## Product Change Notification

**1. ECR #:** 187852  
**Notification #:** 488

**3. Series:**  
• LSHM - 0.50MM TERMINAL/SOCKET COMBO

**4. Part #'s Affected**  
• LSHM-1XX-XX-X-DH-A-S-K-TR

Existing design - Front view

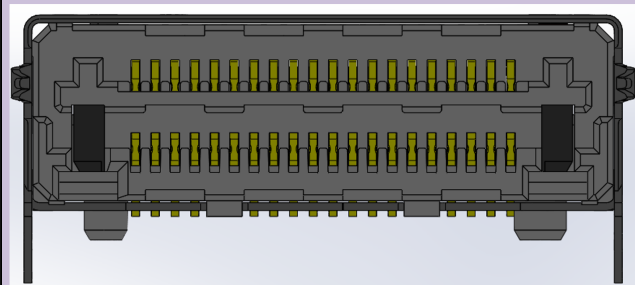
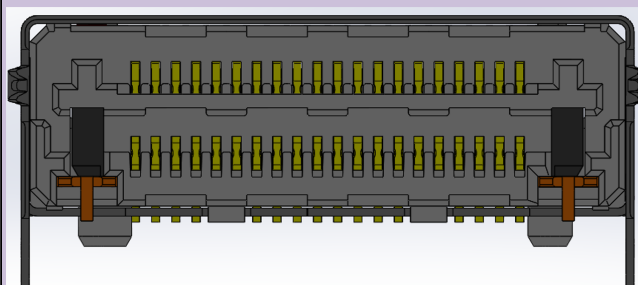
**5. Description of Change:**  
Adding a weld tab to the assembly on both sides and removing the feet from the shield.

1. The revised design improves the coplanarity while retaining the same specification on the print, 0.10 mm [.004 inch]. 2. The revised design will not affect the footprint.
